Errata Sheet

Rel. 1.7, 2010-02-19

Device	**TC1766**
Marking/Step	**EES-BB, ES-BB, BB**
Package	**PG-LQFP-176-2**

This Errata Sheet describes the deviations from the current user documentation.

Figure 1

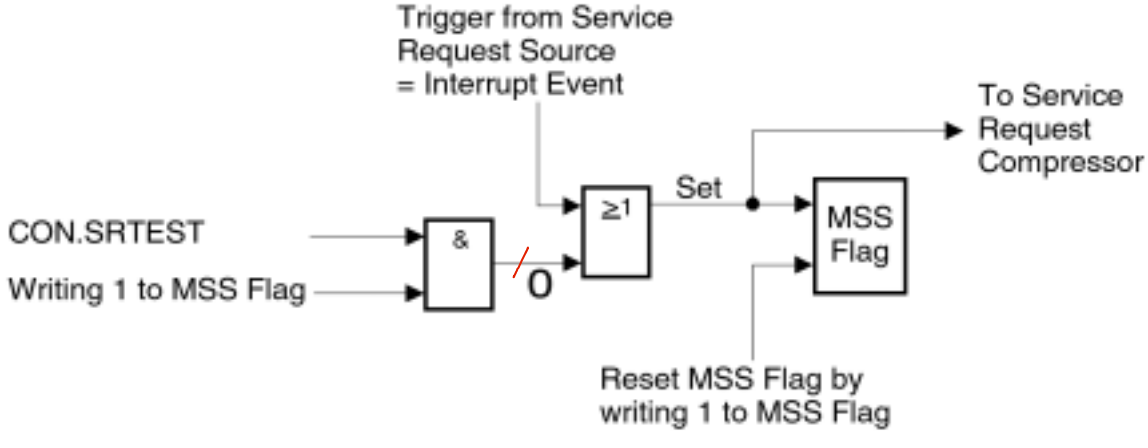
ADC_TC.023 Setting the MSS-flag doesn't generate an interrupt in TEST-MODE

It is possible to generate a software triggered interrupt event in TESTMODE (ADCx_CON.SRTEST=1) by setting one of the bitflags in register ADCx_MSS0/1. Due to the fact, that this mechanism is not working, it is not possible to generate a corresponding interrupt by software.

Workaround

Figure 2 Timing concerning equidistant multiple timers

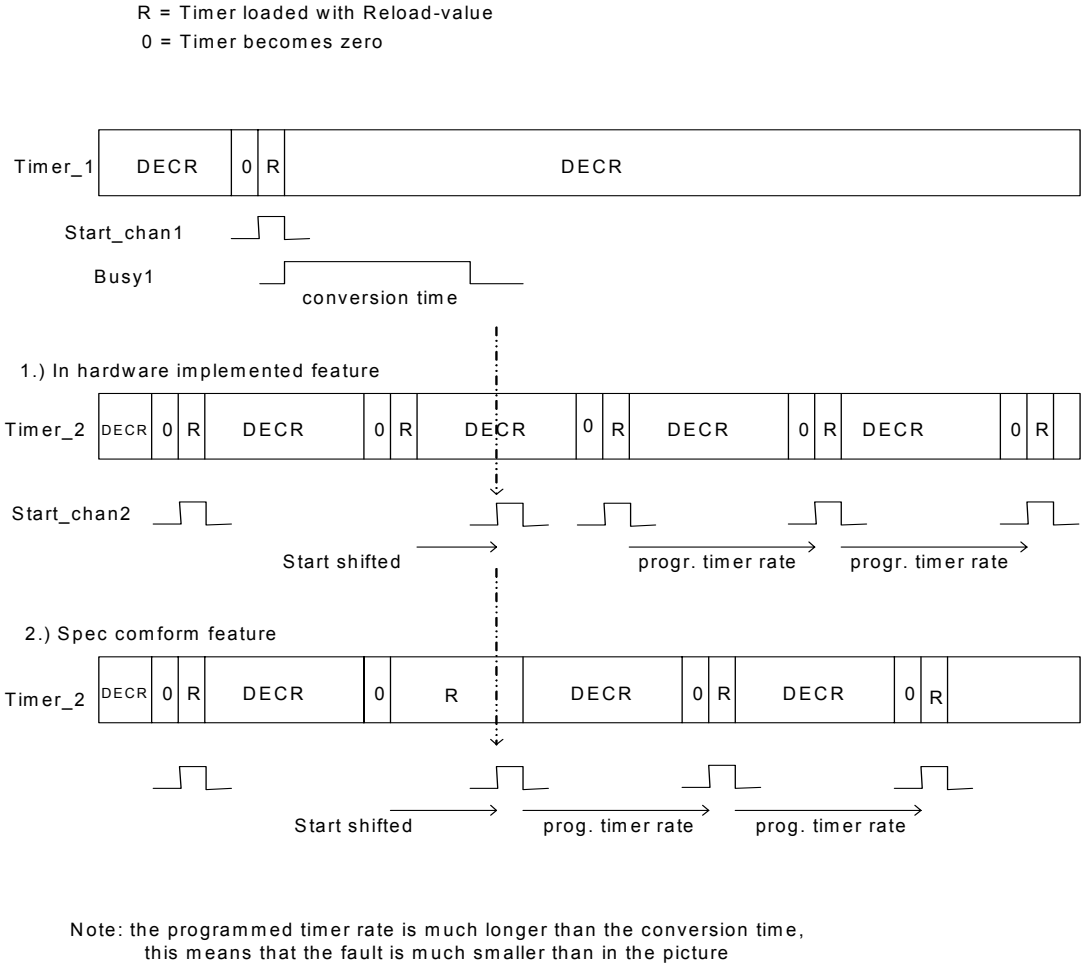
The correct behavior would be a reload when the requested conversion (of channel_2) is started.

Therefore the start of conversion for channel_2 is delayed by maximum one conversion-time. After this delay it will be continued with equidistant conversion-starts. Please refer to the following figure.

Workaround

Figure 4 Uncritical transmission

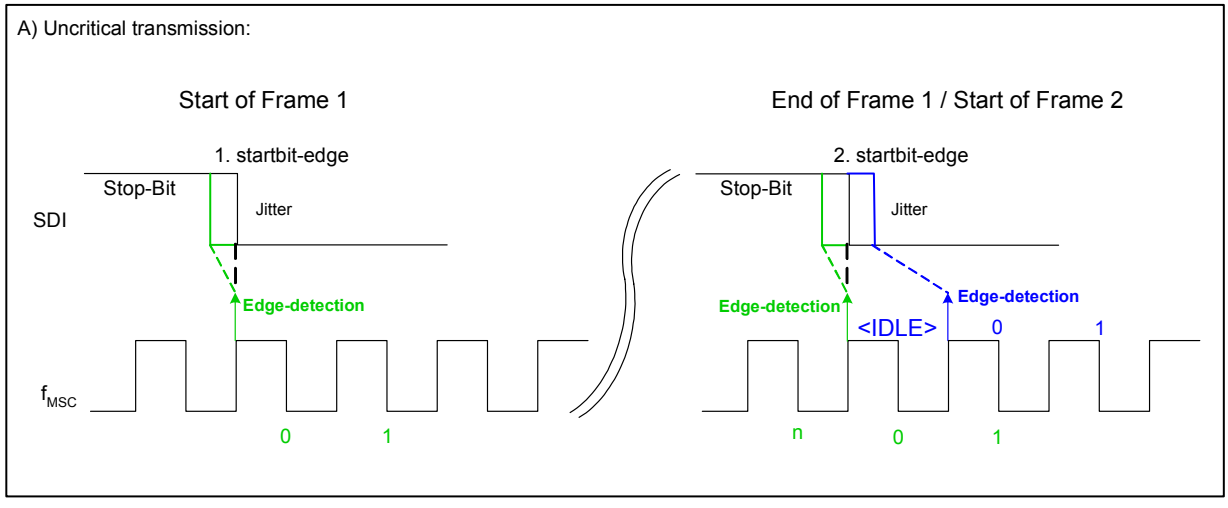
As the falling startbit edge is shifted to the left of the rising clock edge (**Figure 4** left), there occurs a secure detection of the next start-bit edge in the last cycle of the previous frame (here cycle n, **Figure 4** right) independant from the applied jitter to this edge.

Figure 5 Critical transmission

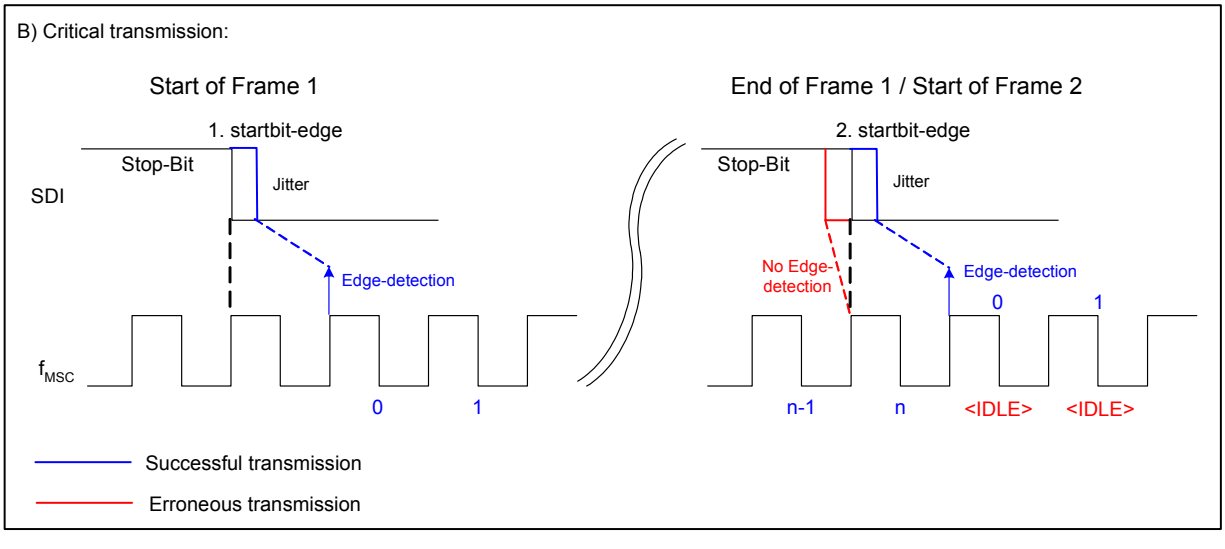
If the high-low edge of the start-bit in the first frame is just not detected by the near clock-edge (**Figure 5** - left) and the start-bit edge of the second frame is jittering to cycle n-1 (**Figure 5** - right, red coloured), then an erroneous transmission will take place. In this case the state-machine switches to IDLE after the last state n and wakes up on the next falling edge that may be a data-bit recognized as a start-bit. If the start-bit of the second frame is jittering to cycle n (**Figure 5** - right, blue colored), then the state-machine will not switch to IDLE but will start receiving the next frame correctly.

Figure 6 Delay adjustment relative to the module clock

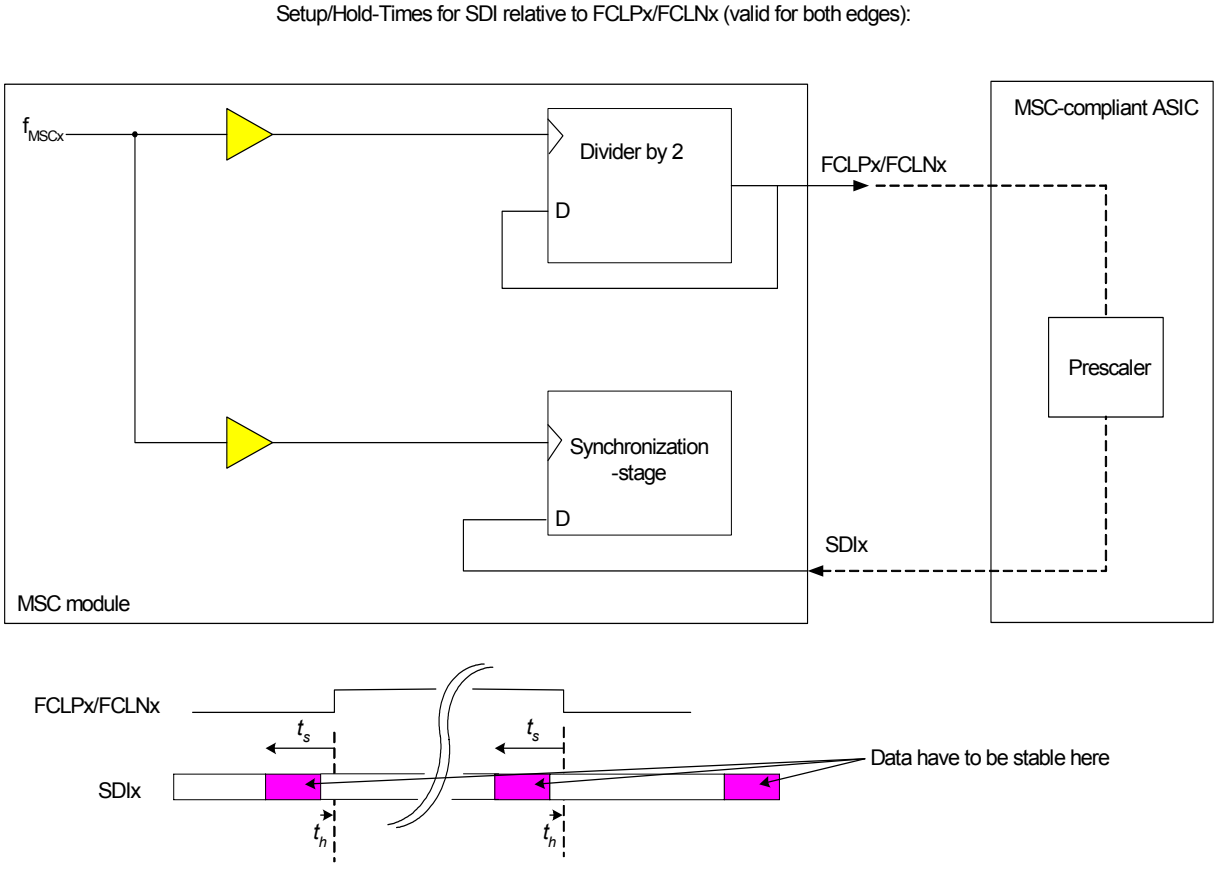
Figure 6 shows the principle blockdiagram of the input synchronization stage of the MSC module.

The delay depends on the maximal skew in the data-stream. For this workaround the downstream clock FCLPx/FCLNx can be measured as reference and the data stream at the input of the upstream channel SDIx has to be adjusted according to the setup- and hold-times of the input-pins SDIx.

Figure 10 Current accuracy range

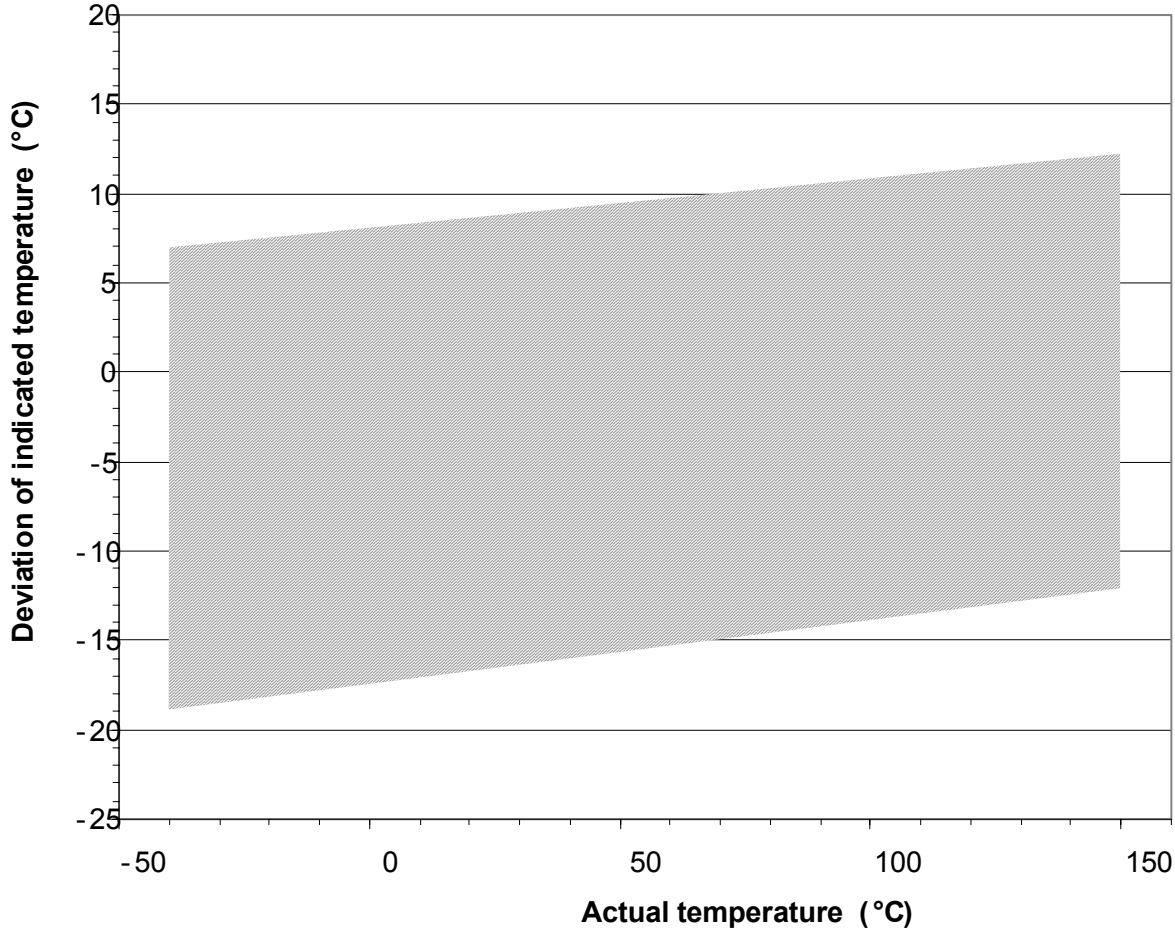
The accuracy of the DTS deviates from the values specified in the Data Sheet. The formulas available on the specification are as follows:

- +/-12°C at T_J = 150°C
- +9/-17°C at T_J = 25°C
- +7/-19°C at T_J = -40°C

Workaround

Figure 11 Exemplary power-up/down sequence

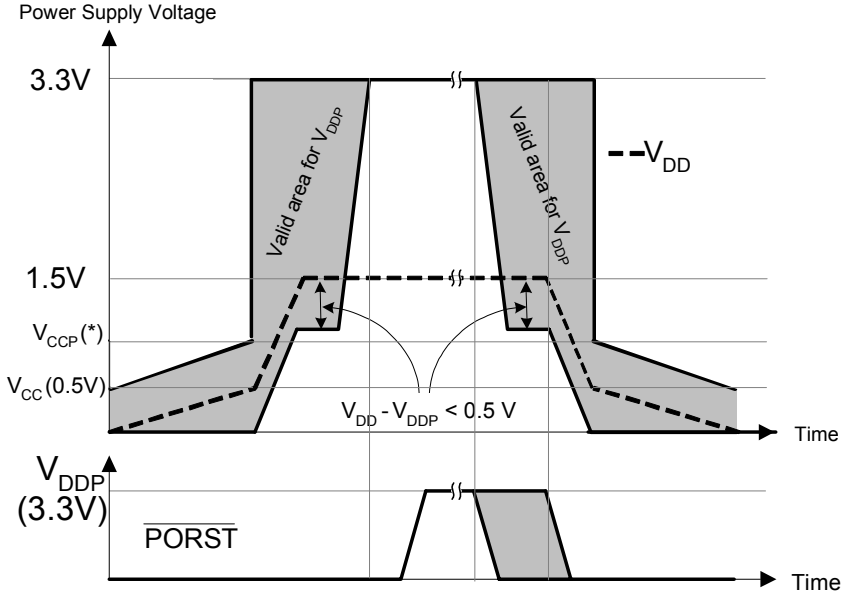
As per Data Sheet, V_{DD} - V_{DDP} < 0.5 V has to be valid at any time in order to avoid increased latch-up risk. The figure below shows the possible V_{DDP} values as shaded region for an exemplary V_{DD} ramp. Moreover, the following rules apply:

- All analog voltages (V_{DDOSC3}, V_{DDM}, V_{DDMF}, V_{DDFL3}) must also follow V_{DDP} power-up/down sequence.
- V_{DDAF}, V_{DDOSC} must follow V_{DD} power-up/down sequence.
- The absolute value of the maximum allowed deviation between any two supplies is 0.5 V while the 1.5V supplies are below their specified operating conditions.
